Technical Note TN-968-SR

TM8100 Mobile Radio Firmware v2.04 Upgrade Instructions

1 March 2005

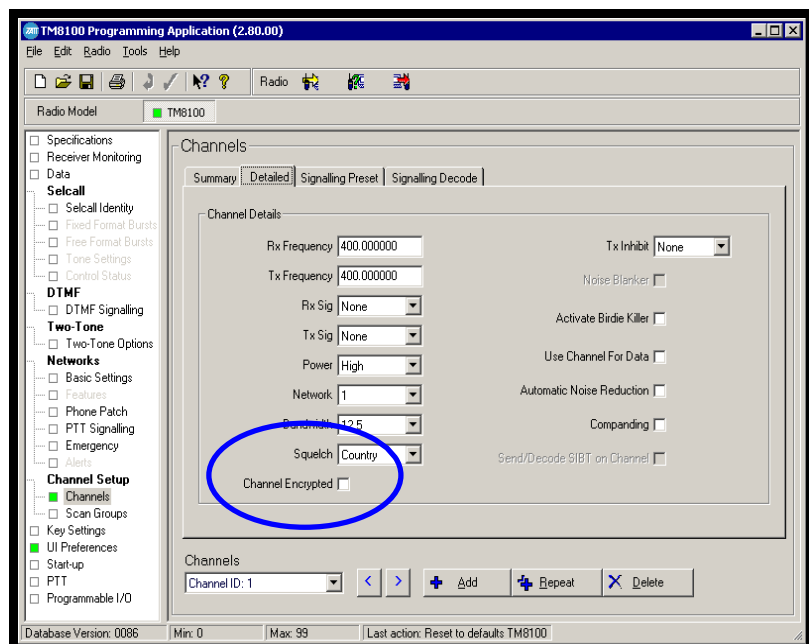
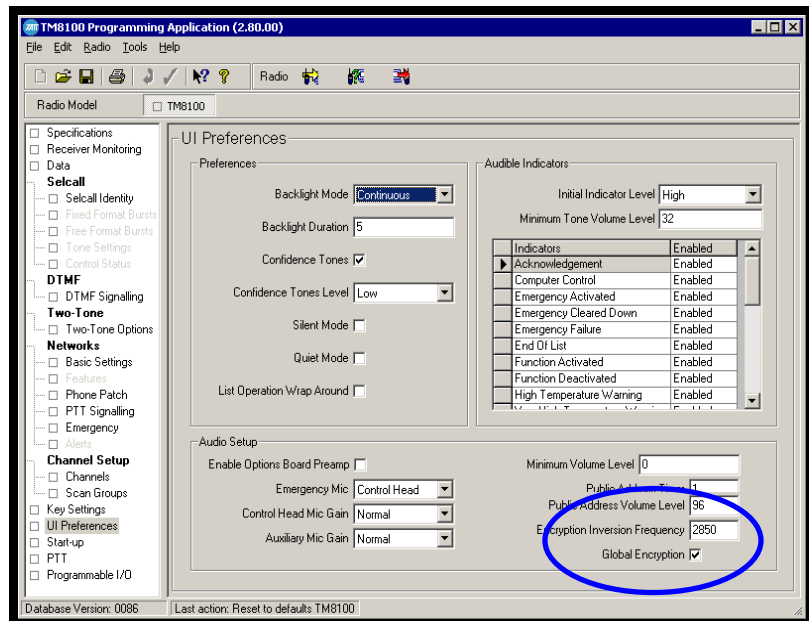
- Encryption Status has been added to the output functions available on the Programmable I/O page. This produces an output indication that encryption has been activated either by the user pressing a programmed function key, or has selected an encrypted channel. The line will deactivate when the user turns off encryption, or an unencrypted channel is selected.

To enable a user to identify the channel they are on is encrypted (or not); set the I/O lines as per the suggestion below.

Pin	Direction	Label	Action	Active	Debounce
AUX_GPIO4	Output	PIN_10	Encryption Status	Low	None
AUX_GPIO6	Input	PIN_9	Toggle F1 Key LED	Low	10

A link-short between Pins 9 and 10 of the Aux DB-15 plug will light the 'F1' LED whenever an encrypted channel is active. Be aware if the channel is then a member of a scan group it will 'beep' whenever the scan passes that channel.

Deferred Calling

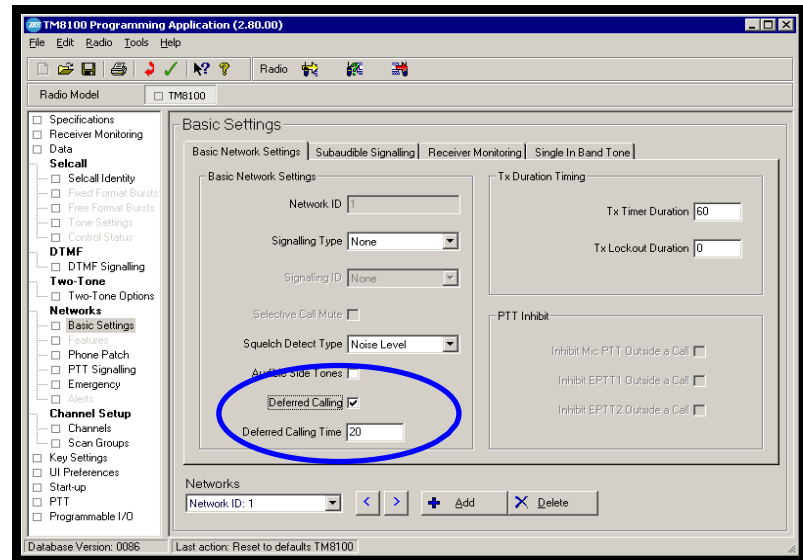
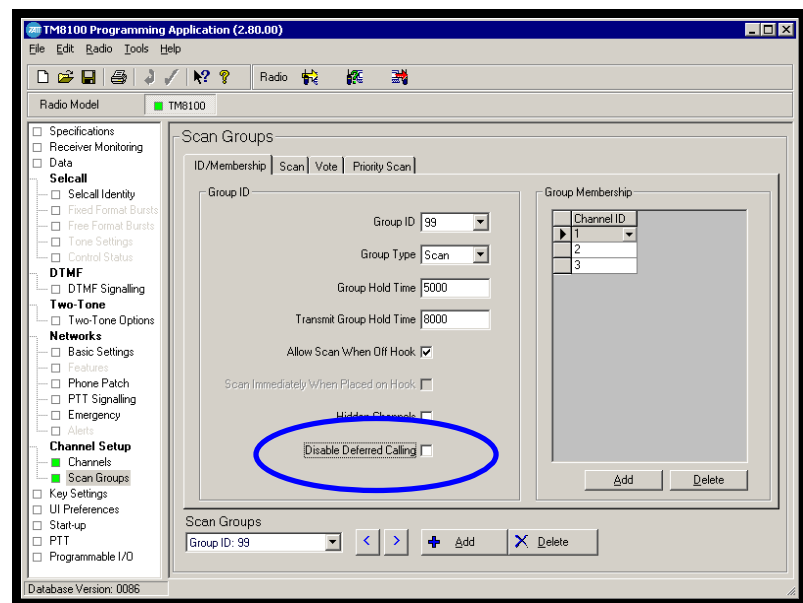
If Deferred Calling is enabled, unsuccessful Selcall or DTMF sequence transmissions will automatically retry after a random period between 500ms and 5seconds.

It will continue doing this until:

- The transmission succeeds or
- The nominated Deferred Calling Time expires or
- There is a user input action (including any key-press).

If Deferred Calling functionality is not desired when Scanning the Scan Groups > ID/Membership tab has the tickbox Disable Deferred Calling to disable this.

Start-Up Channel

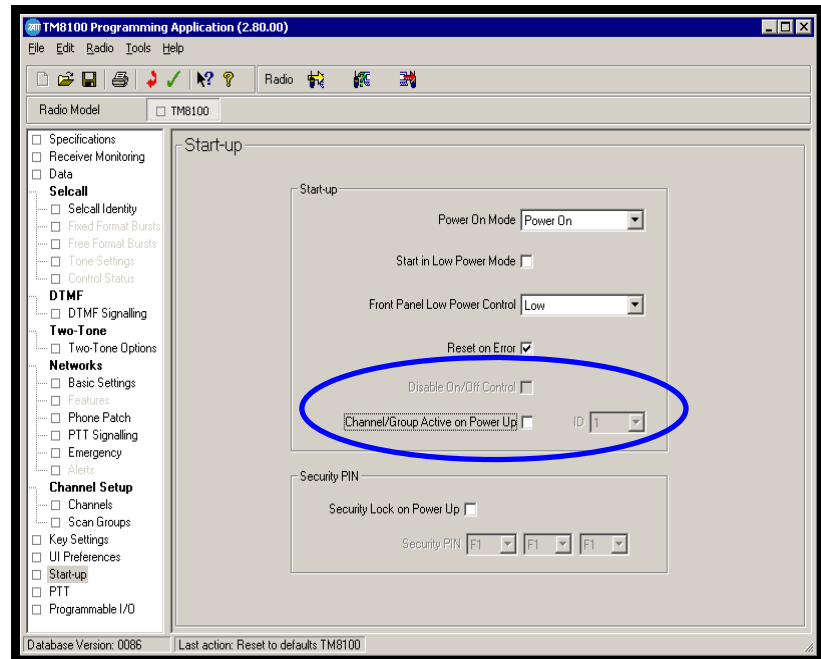
Channel/Group Active on Power Up forces the radio to start-up on a specific Channel or Group regardless of last ID used before being powered-off (this will also occur if the radio resets due to a brown-out with heavy vehicle cranking).
NOTE: BCD inputs have a higher priority, and these will define the actual channel even if this option is enabled.

Once the tickbox is enabled the required channel or group can be picked from the drop-down ID list. Hidden channels will not appear.

FFSK Lead-In Delay

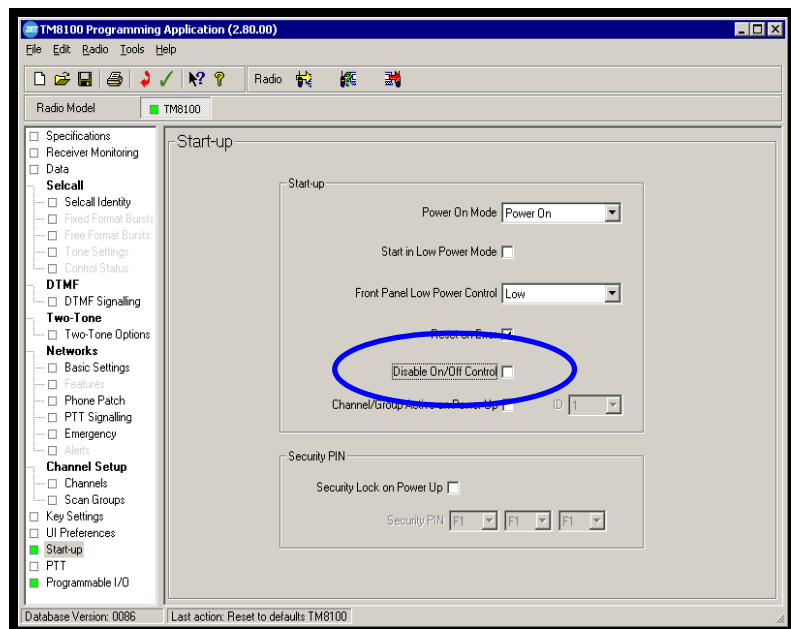
The variable value for FFSK Lead-In Delay has been increased from 1200ms to 5100ms in-line with existing products such as the T2000-A75 and the Orca5000.

The FFSK Lead-In Delay field, found in Data > RF Modems, can be set from 20ms to 5100ms in 5ms steps.

Dual Busy Status Outputs

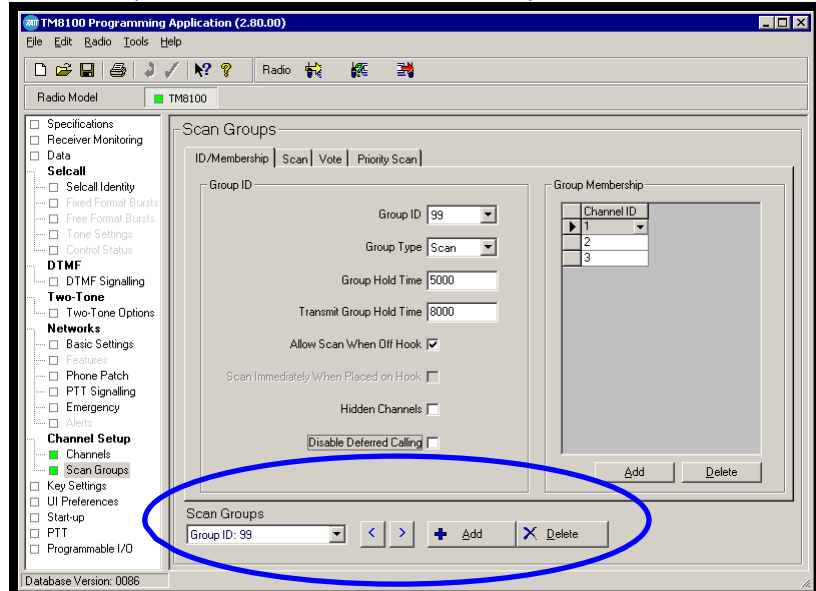
The TM8100 can now provide two BUSY STATUS outputs simultaneously. These can be assigned to any Programmable I/O outputs and each can also be configured differently. Raised as Focus 17349.

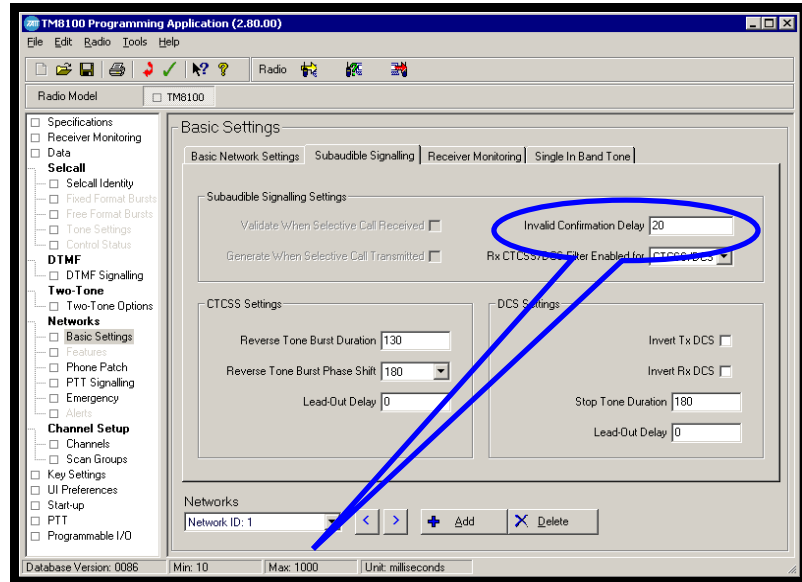
The Abbreviated Label on Scan Groups > Scan > Scan Group Display Indicator now appears as:

- TM8115 – “SC”
- TM8110 – “o” (looks like the bottom half of an eight).

IOP Pins as they appear on the TMAA01-05 Options Extender Bd: DB-15(HD)

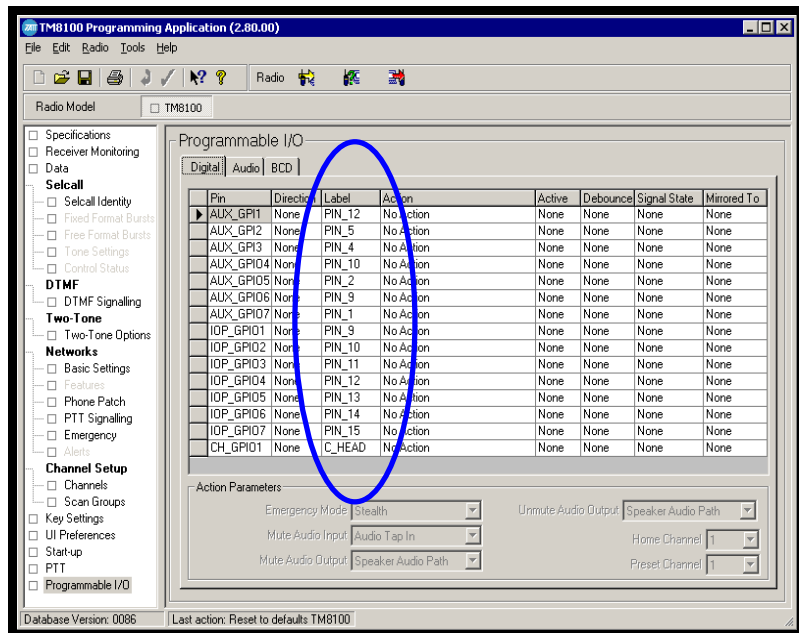
These define the specific Pin on the respective connectors allowing easier interfacing. The AUX port is the rear DB-15, IOP is the 18-way MicroMatch on the main board and CH_GPIO1 is Pin 8 of the display heads' Microphone RJ-45 socket. These can still be re-labelled to any description as before but will revert to 'None' if the label is subsequently deleted. Raised as Focus 17495.

- IOP_GPIO1 = Pin 15
- IOP_GPIO2 = Pin 14
- IOP_GPIO3 = Pin 13
- IOP_GPIO4 = Pin 10
- IOP_GPIO5 = Pin 9
- IOP_GPIO6 = Pin 5
- IOP_GPIO7 = Pin 4
